LIGHTNING IMAGING SENSOR (LIS)

TROPICAL RAIN MEASUREMENT MISSION (TRMM) CONFIGURATION

OPTICAL TRANSIENT DETECTOR (OTD)

OTD RANDOM VIBRATION ISSUE

DATA COMPARISON

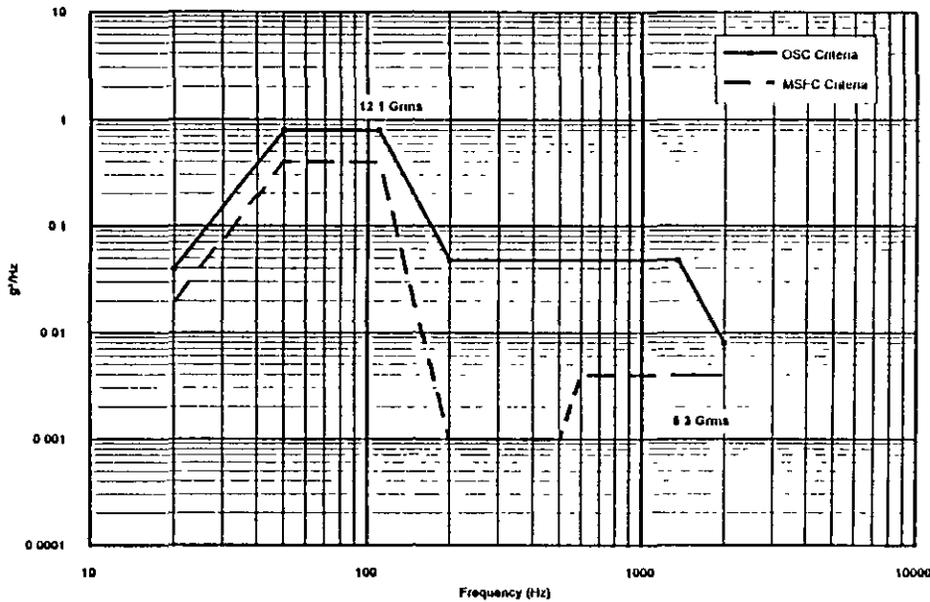
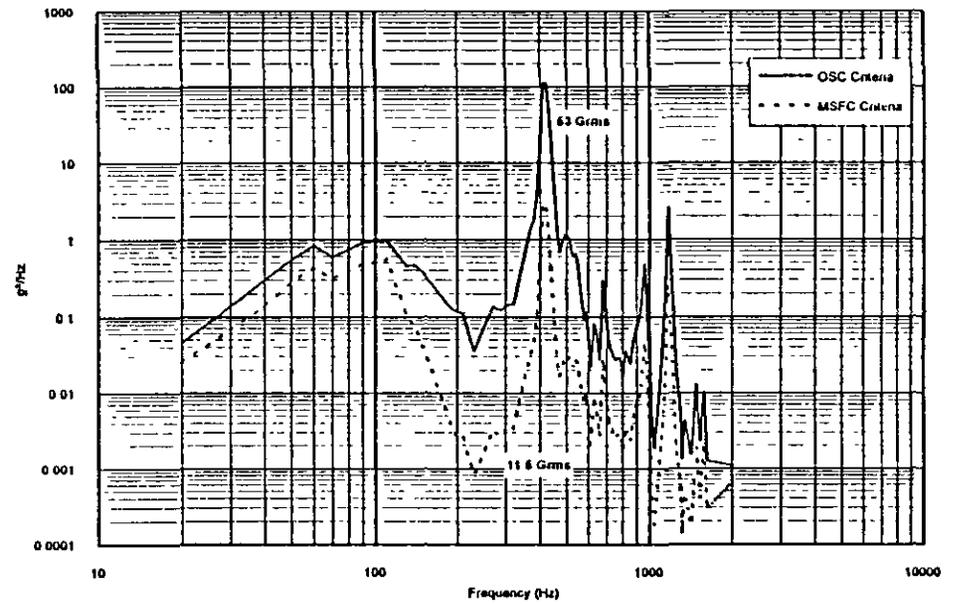
- **EB23 has concerns relative to the functional aspects of the lens assembly and local board-mounted electrical components as a result of environment/load increases**
- **ICD random vibration criteria (derived by OSC) is maximum-predicted +3 dB and is based on FEM response (for 20-200 Hz) and MIL-STD-1540B (for 200-2000 Hz) envelope for all three axes**
- **This generic approach provides a great amount of conservatism in the shelf's in-plane axes above 200 Hz**

- ED23 criteria is derived from Orbital Sciences finite element model predictions below 200 Hz and response data from honeycomb panel exposed to Pegasus acoustic environment at MSFC

- **ED23 recommends testing to the newly derived criteria**
 - **Use one criteria for all three axes**
 - **Test duration will be 60 seconds per axis**
- **This criteria provides protoflight qualification for the random vibration environment**

DATA COMPARISON

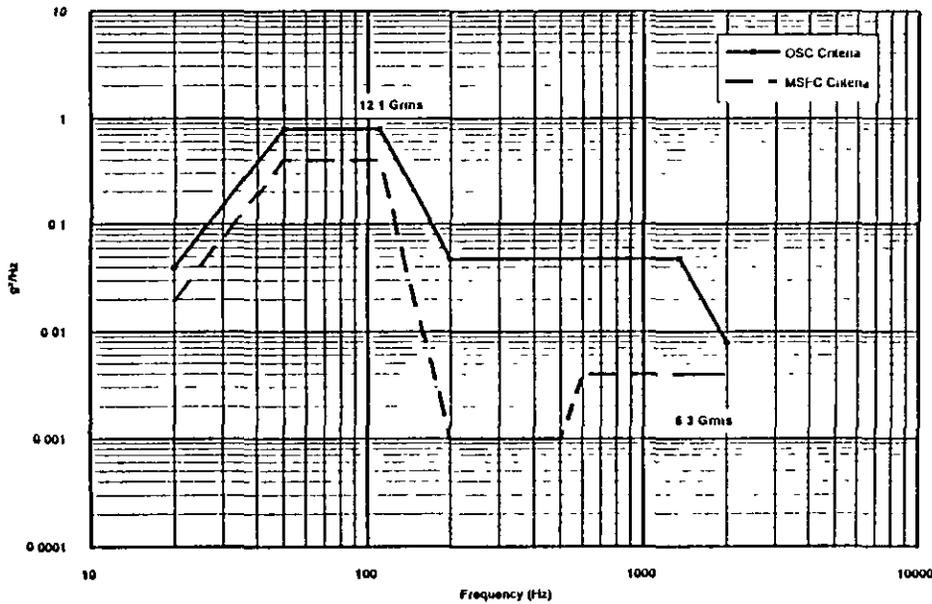
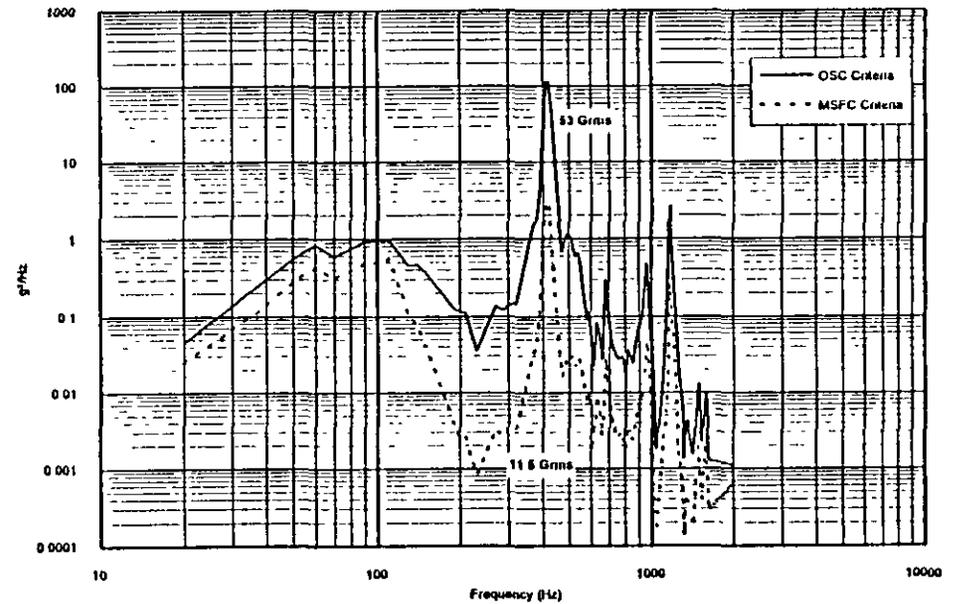
- **EB23 has concerns relative to the functional aspects of the lens assembly and local board-mounted electrical components as a result of environment/load increases**
- **ICD random vibration criteria (derived by OSC) is maximum-predicted +3 dB and is based on FEM response (for 20-200 Hz) and MIL-STD-1540B (for 200-2000 Hz) envelope for all three axes**
- **This generic approach provides a great amount of conservatism in the shelf's in-plane axes above 200 Hz**

- ED23 criteria is derived from Orbital Sciences finite element model predictions below 200 Hz and response data from honeycomb panel exposed to Pegasus acoustic environment at MSFC

- **ED23 recommends testing to the newly derived criteria**
 - Use one criteria for all three axes
 - Test duration will be 60 seconds per axis
- **This criteria provides protoflight qualification for the random vibration environment**
